Department of Toxic Substances Control

October 20, 2017

The Department of Toxic Substances Control (DTSC) has received the draft Radiological Data Evaluation Findings Report (Report) for Parcels B and G Soil dated September 2017 and received on September 29, 2017. DTSC has reviewed the Report and has the following comments as presented below. Our comments pertain to the Parcel G Navy recommendations and general information provided in the Report. Our comments are based on our review of the fill units, as well as the California Department of Public Health, Environmental Monitoring Branch (CDPH EMB) and United States Environmental Protection Agency (EPA) findings on the evaluation forms for the building soil units, and EPA's findings on the evaluation forms for the trench units.

Ac-228 concentration by survey type: Parcel_G Trench Unit S0067

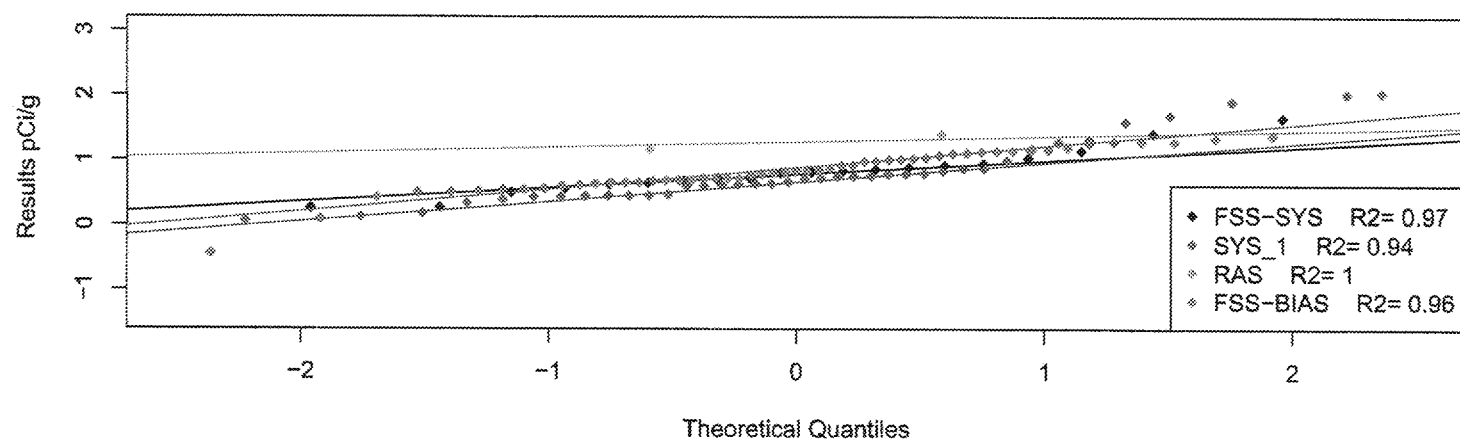
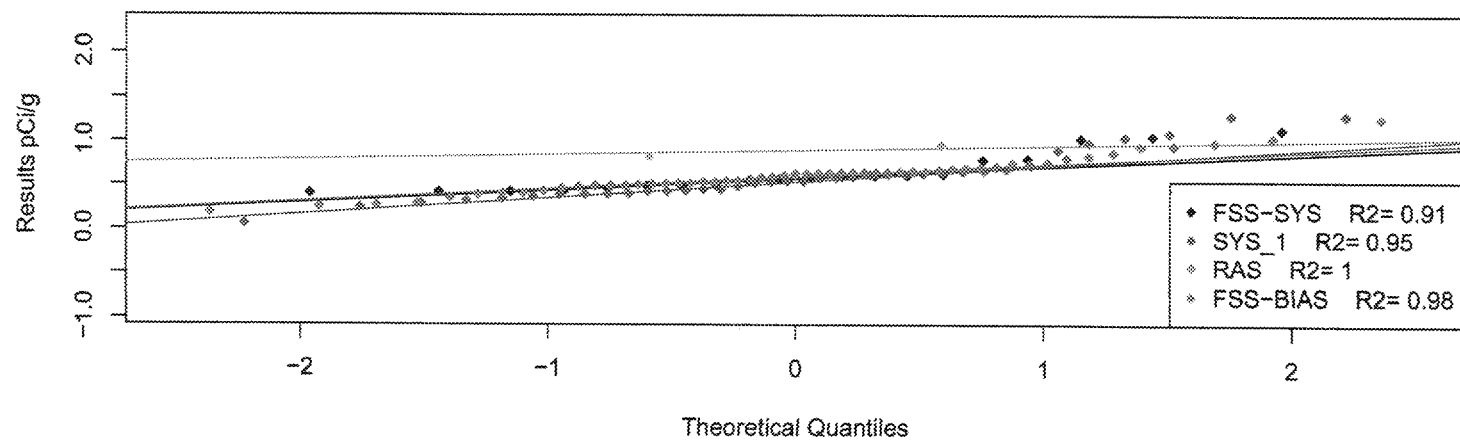
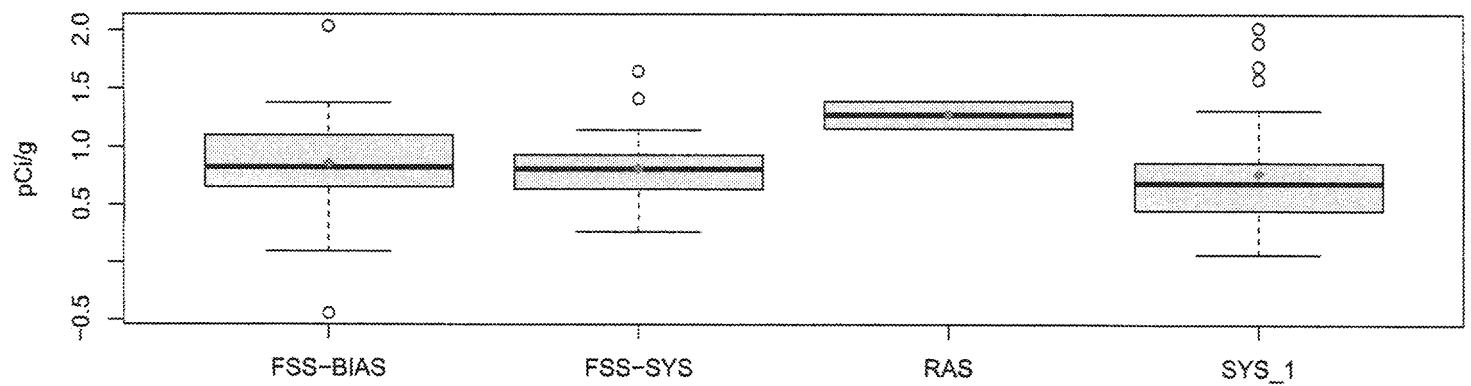
8. Please revise and/or replace the Box Plots and Quantile Plots provided in the report with ones that are more readable, e.g. same scale and within the same plot for better interpretation. See the attached examples provided by Langan environmental consulting.
